Overview

The purpose of this notification is to communicate the addition of new shipping trays for the VO48/VOG48 TSOP packages.

Table 1: PCT Technology Tray Details

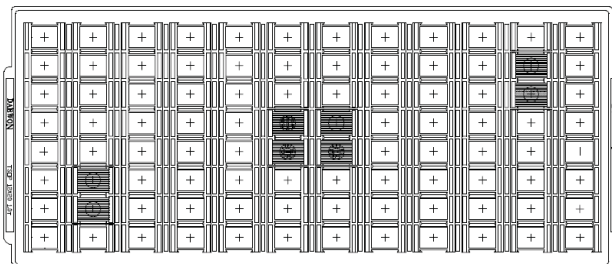
Table 1 and Figure 1 provide further details of the PCT Technology shipping tray.

Figure 1: Tray Details

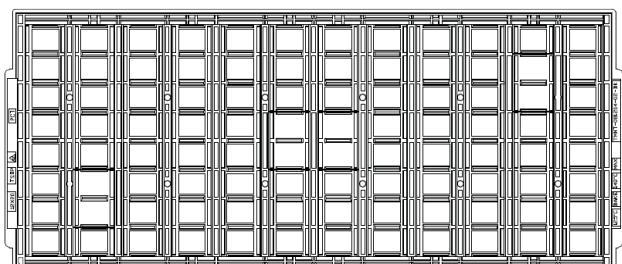
Xilinx is adding new shipping trays produced by PCT Technology for the VO48/VOG48 TSOP packages.

The new PCT Technology tray matrices are designed to be compatible with current Daewon shipping trays. The PCT Technology trays are stackable with Daewon trays, and will have the same X/Y tray dimensions as the Daewon trays.

Xilinx will begin using the new shipping product in the PCT Technology trays starting May 1, 2008.
